Safety Recall Code 0829 - BLAST FUEL VENT ROLLOVER VALVE ASSEMBLY

Figure 1. Rollover Valve And Fuel Cap Assembly

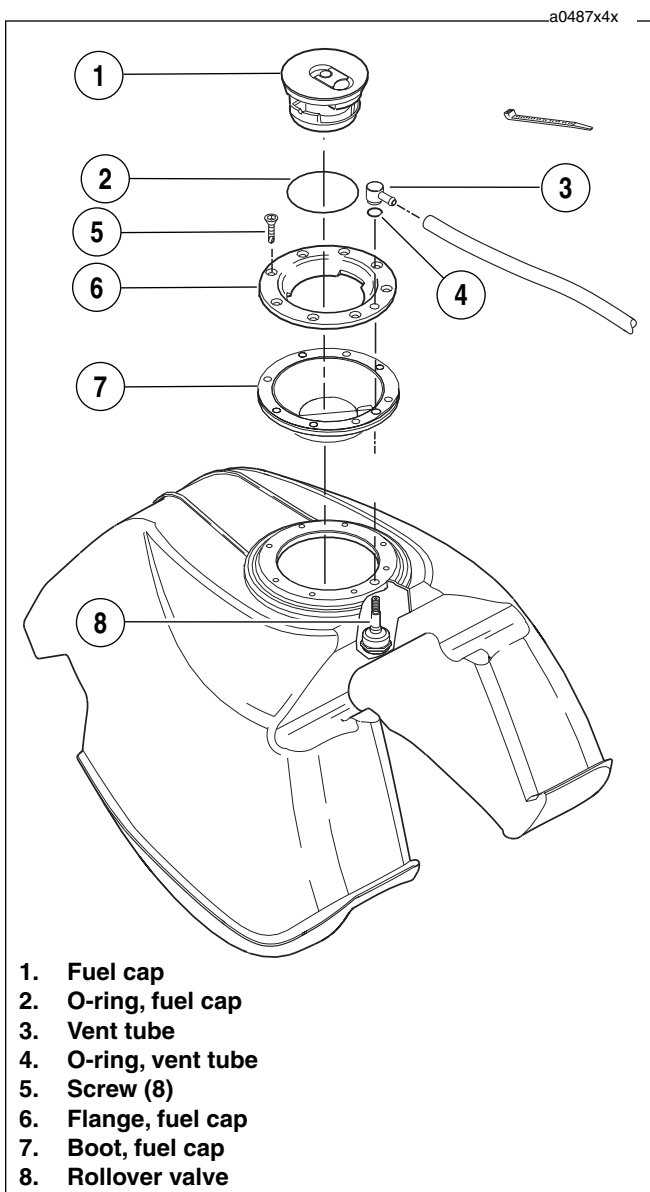
See Figure 1. Buell Motorcycle Company has learned that certain 2004 model year Blast vehicles built between 1/6/2004 and 6/2/2004 have a fuel tank vent valve assembly that could malfunction. This condition could prevent sufficient fuel flow, which may cause the engine to unexpectedly stall. Accordingly, Buell Motorcycle Company is conducting a voluntary recall campaign to formally recall all potentially affected motorcycles. This condition will be remedied by replacing the fuel tank vent valve on all potentially affected vehicles. In addition to the above mentioned motorcycles a number of rollover valves and certain fuel tanks shipped from the P&A warehouse between 8/11/2003 and 6/3/2004 are suspect as well.

The Fuel Vent Valve recall kit (Part No. 94335Y) consists of:

Quantity	Part No.	Description
1	P0107.8C	Vent Valve
1	Y0305.8B	Cable Strap
1	P0106.8	O-ring
